Environmental Assessment and Finding of No Significant Impact for the Palisades Nuclear Plant Reauthorization of Power Operations Project

Final Environmental Assessment and Finding
of No Significant Impact

Docket Number: 050-0255

Issued: May 2025

Figure 2-2 A Satellite Image Showing the Palisades Nuclear Plant Site Boundary in Southwest Michigan. Source Data: HDI 2024-TN10670: RAI-GEN-1.

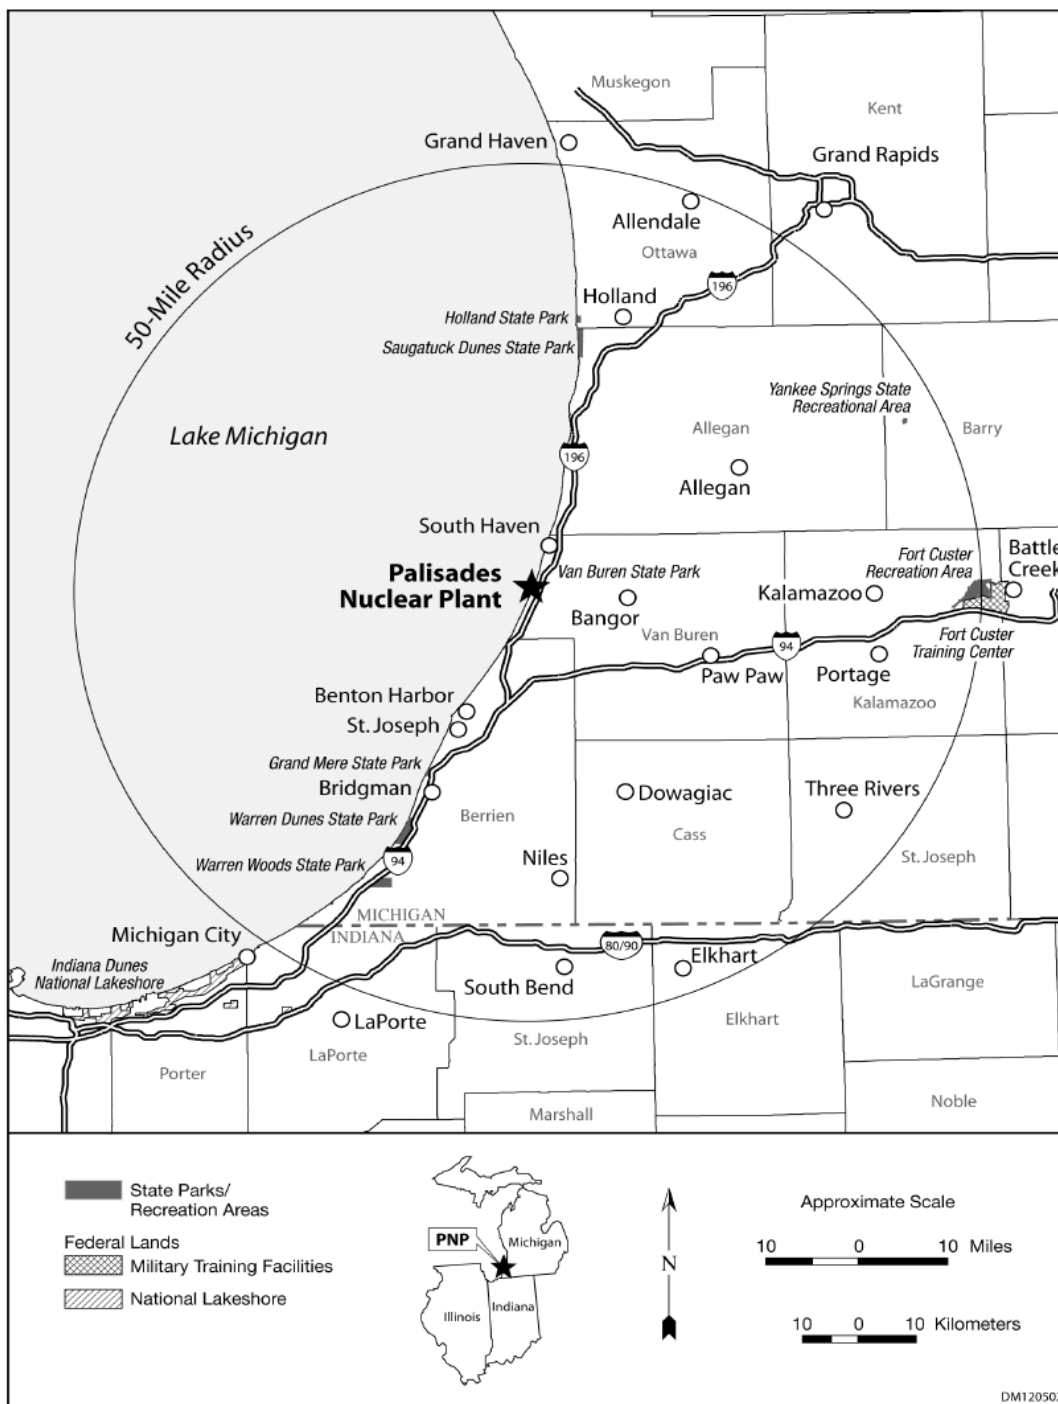
Comment: Fig. 2-2 shows just how close the dry cask storage is to the Van Buren State Park campground. What is the radiation dose, from gamma and neutron "shine," from the dry casks to people staying at the campground area? (23-4-3 [Kamps, Kevin])

Figure 2-3 Palisades Nuclear Plant Site Layout. Source: NRC 2006-TN7346.

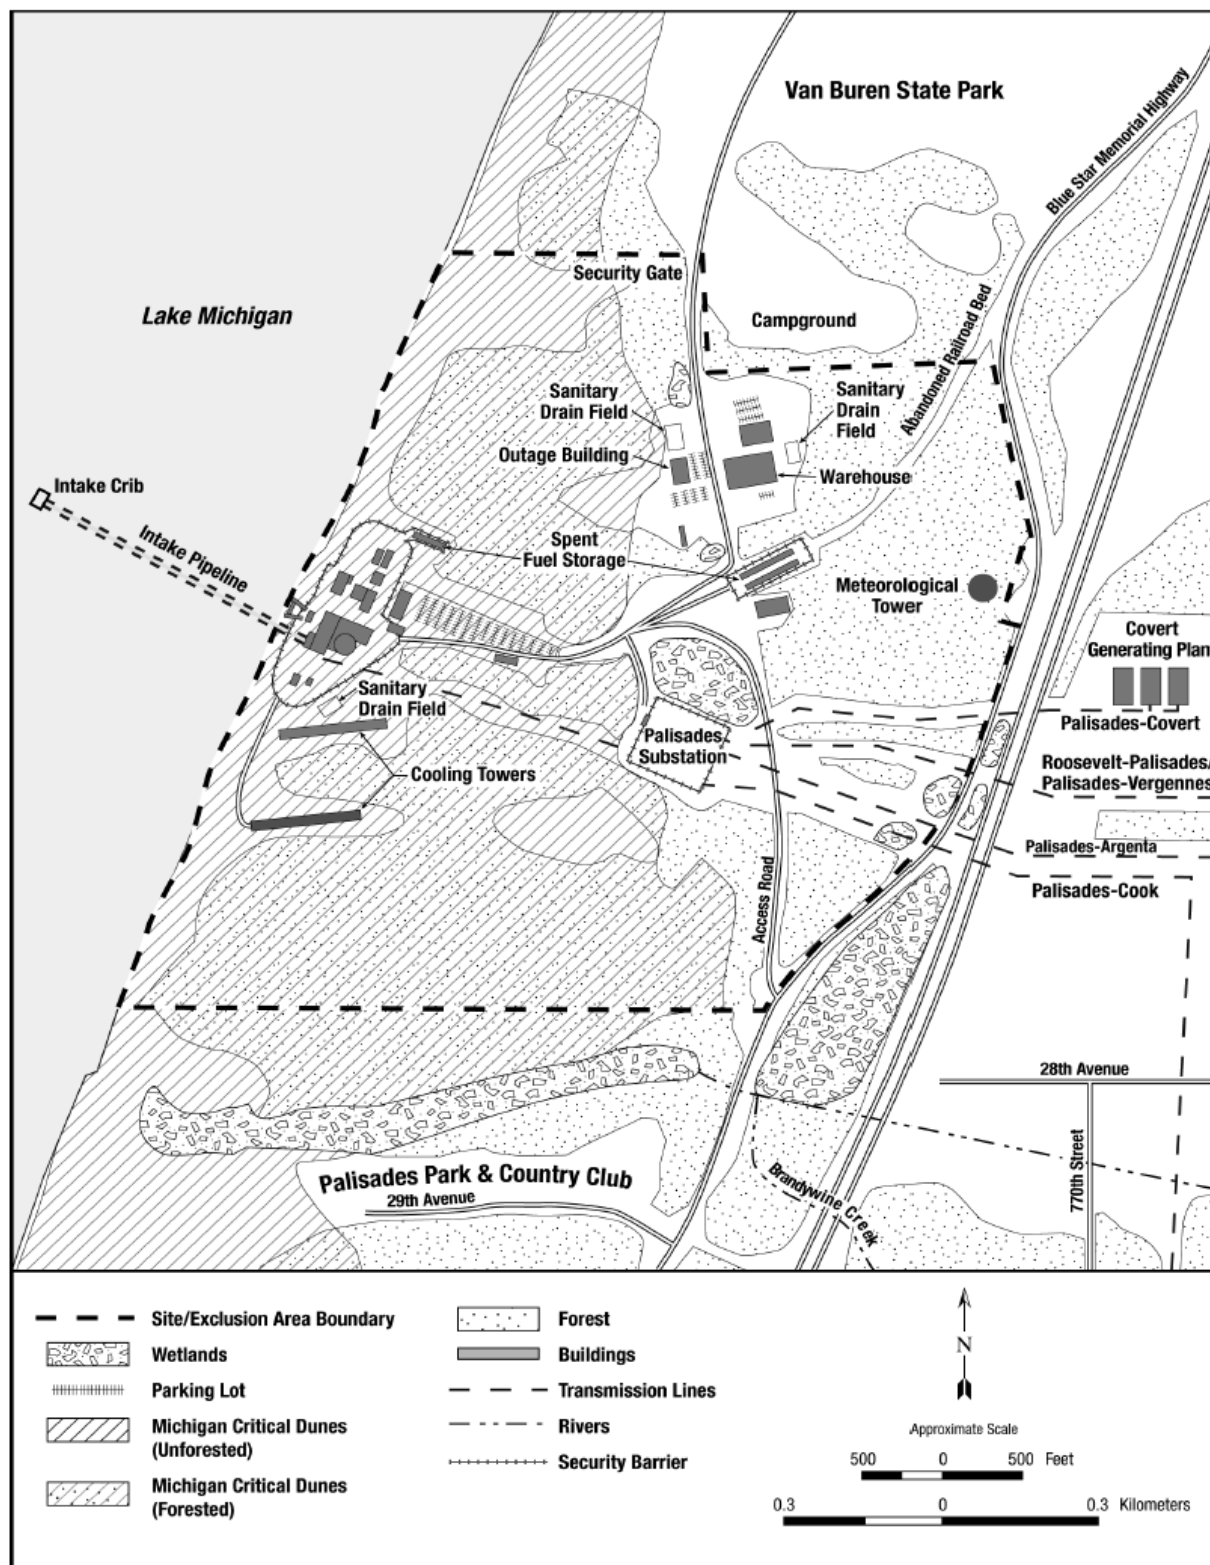
Comment: Palisades is bordered by Van Buren State Park on the north and a privately owned residential and lakefront recreational community, Palisades Park Country Club, on the south (see figure 2-3 of this EA). {**Emphasis added.**}

Comment: Fig. 2-3 - finally a mention of PPCC (Palisades Park Country Club! Why was it not mentioned above? The figure also shows how very close dry cask storage is to the Van Buren State Park campground. Routine operations at PNP are bad enough impacts on these very close by population centers. Catastrophic releases of hazardous radioactivity at PNP would be even worse for people at these immediately adjacent locations, in terms of human health and environmental impacts. (23-4-4 [Kamps, Kevin])

Figure 3-3 Stormwater Drainage System Map at Palisades Nuclear Plant. Source: HDI 2024-TN10670: RAI-SW-4.

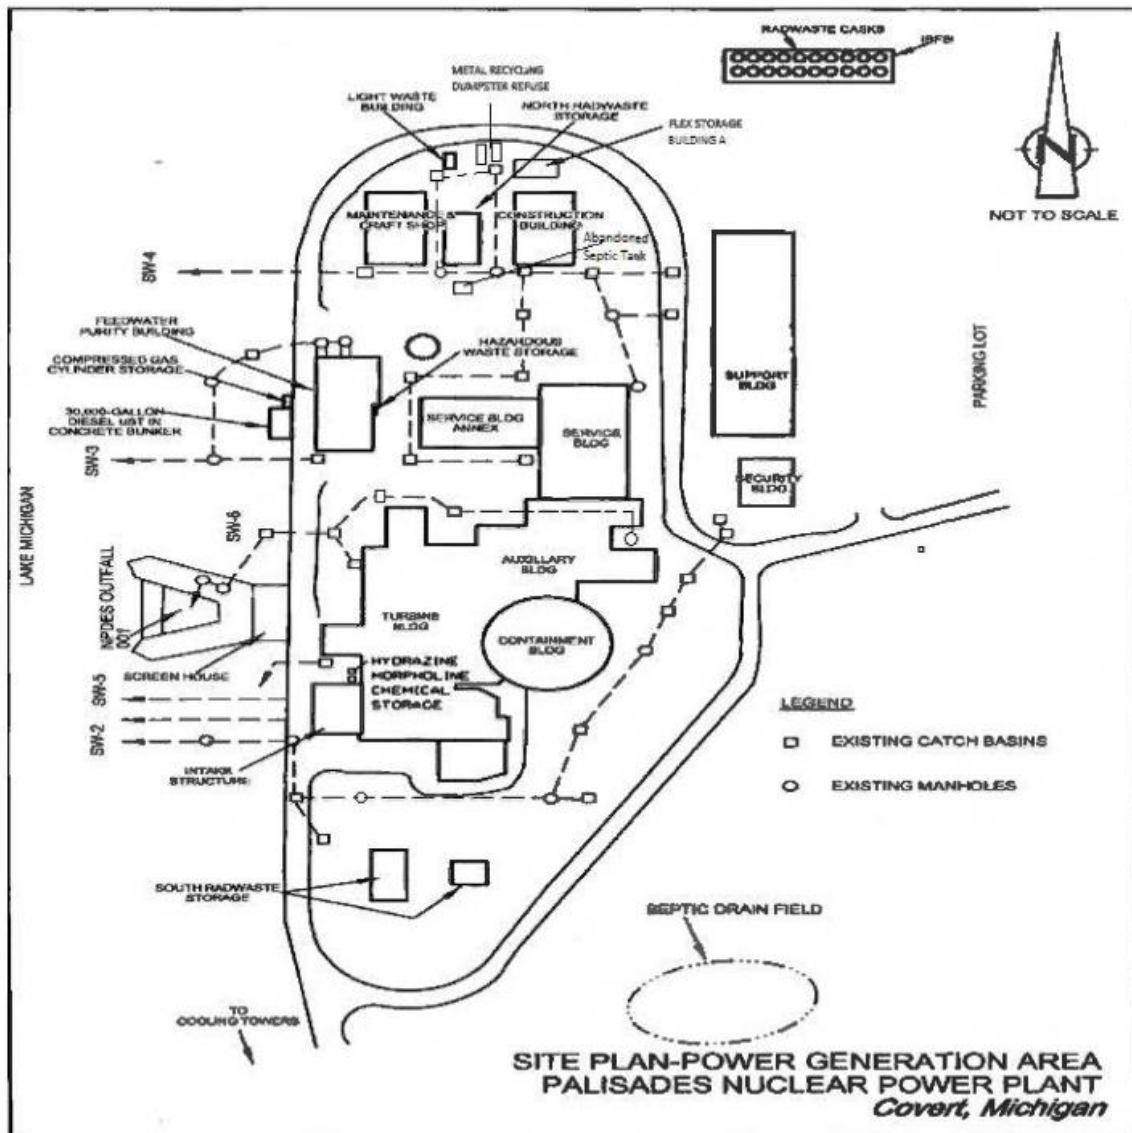
Stormwater for the rest of the Palisades site is drained by a stormwater drainage system that eventually discharges into Lake Michigan (figure 3-3 below).

Figure 3-4 Michigan Critical Dune Areas and National Wetlands Inventory Wetlands within the Palisades Nuclear Plant Site Boundary. Data Sources: MEGLE 2023-TN10860; HDI 2024-TN10670: RAI-GEN-1.

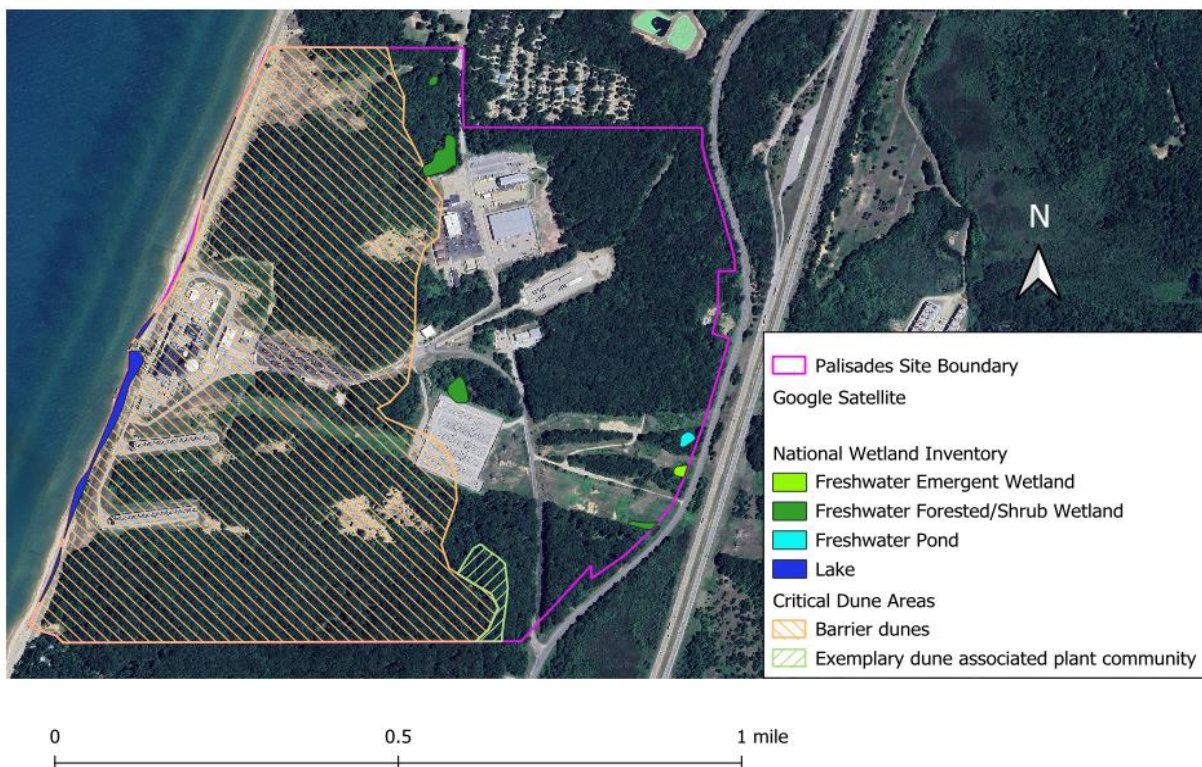
Comment: Figure 3-4

Response: The commenter is concerned with the effects that the construction and operation of the Palisades plant has had in the past on the wildlife habitat provided by the CDAs and lake shoreline on the site. NRC considered the initial licensing of Palisades in the cumulative effect analysis for all resource areas, as described in EA Section 3.1.4. Sections 3.2.1 and 3.6.1.1 of the EA describes the critical dunes remaining on the site, and Figure 3-4 shows the location and extent of CDAs on the Palisade site. EA Section 3.6.2 describes the potential further impact to these remaining dune areas from preparations for resumption of power operations on CDAs. This comment provides no new and significant information and, therefore, no changes were made to the Palisades EA as a result of this comment.

Figure 3-5 Area of Potential Effects and 1 mi (1.6 km) Buffer Area at the Palisades Nuclear Plant Site. Source: HDI 2024-TN10670: RAI-GEN-1.

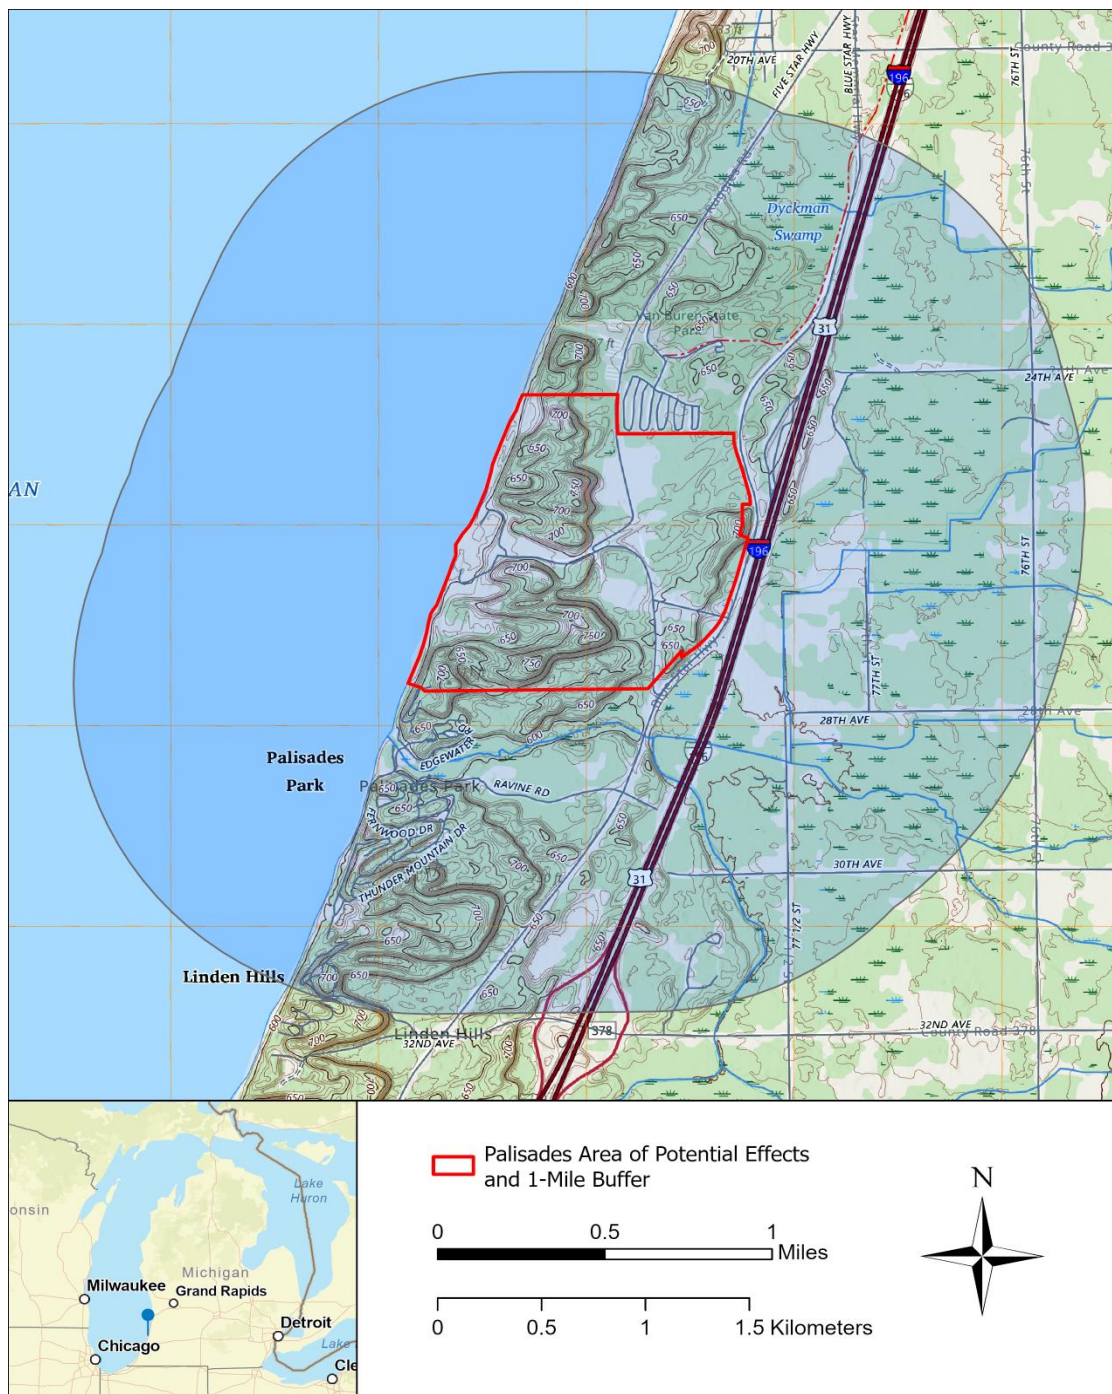
Comment: Preparation Impacts:1-5 Proposed activities would occur only in previously developed areas of site, and no forest would be disturbed (figure 3-5 of this EA). Preparation activities are expected to occur over an 18-month period. The applicant has estimated that approximately 3,000 truck deliveries would take place over this period (HDI 2024-TN10670: RAI-GEN-1). Temporary increases in noise and traffic over this time period are unlikely to alter Indiana bat use of the site. **Bat collisions with vehicles and human-made structures at nuclear power plants are not well documented but are likely rare based on available information (NRC 2024-TN10161: p. 3-63).**

Response: *This comment addresses forest impacts discussed during a conversation between FWS and NRC staff on March 12, 2025 (FWS 2025-TN11909). The in-scope transmission lines lie within the site boundary and are those from Palisades main transformer and the Palisades substation. The 2006 LR (NRC 2006-TN7346: Figure 2-3) depicts the in-scope transmission lines passing from transformer to the substation through non-forested habitat. EA Figure 2-2 displays a current image of the Palisades site and infrastructure and shows site boundary (outlined in red), plant infrastructure, and habitats. Onsite landscape maintenance practices and impacts from those practices, as described in EA Sections 3.6.2 and 3.6.3 include ground below in-scope transmission lines. No changes were made to the Palisades EA as a result of this comment.*
